Draft Environmental Impact Statement (DEIS)
Proposed Chehalis River Basin Flood Damage Reduction Project

DEIS Comments by Jarred Figlar-Barnes

Re: Comments on Revised Draft EIS for the Proposed Chehalis River Basin Flood Damage Reduction Project (Publication No. 25-06-008)

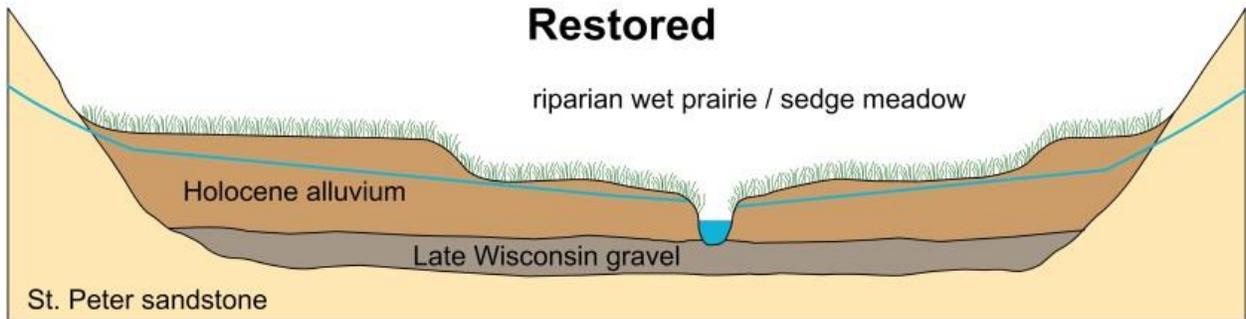
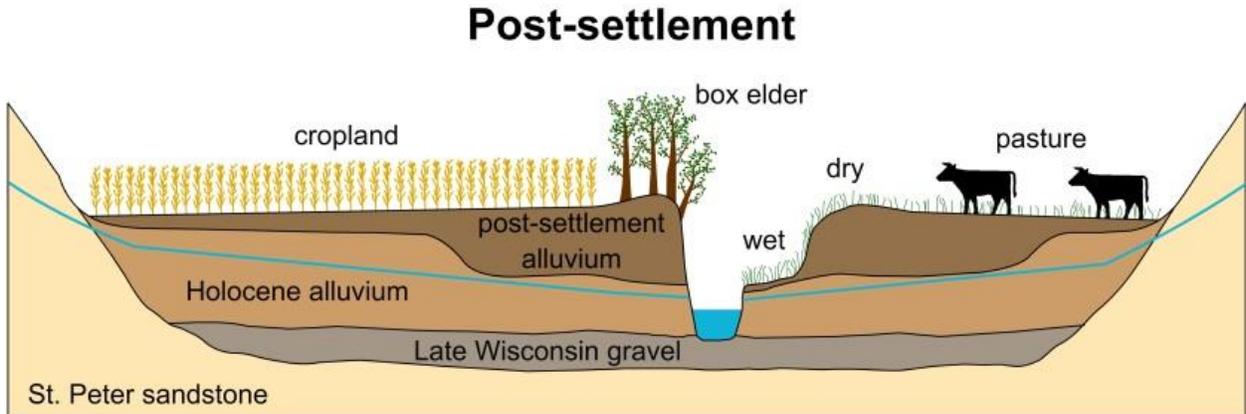
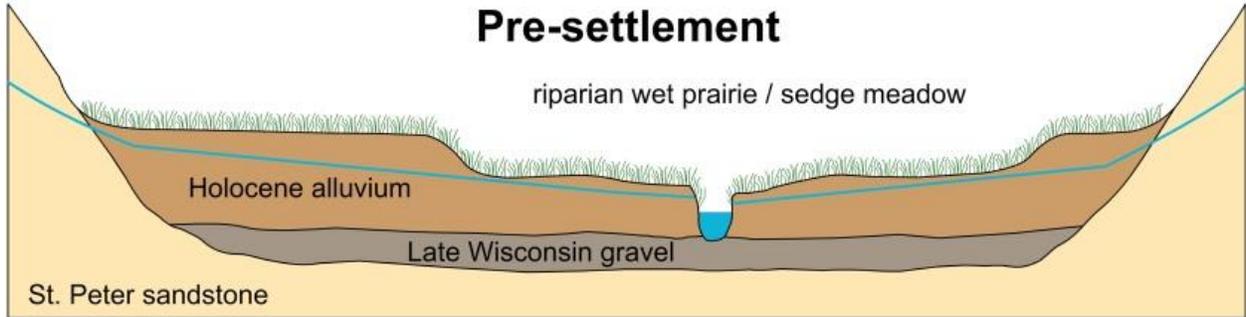
So, with all of that said, has this alternative been considered? If not, why? And can it be considered as an alternative to the dam?

See the below for cross section examples of floodplain restoration taken from another part of the country, however the principles are the same:
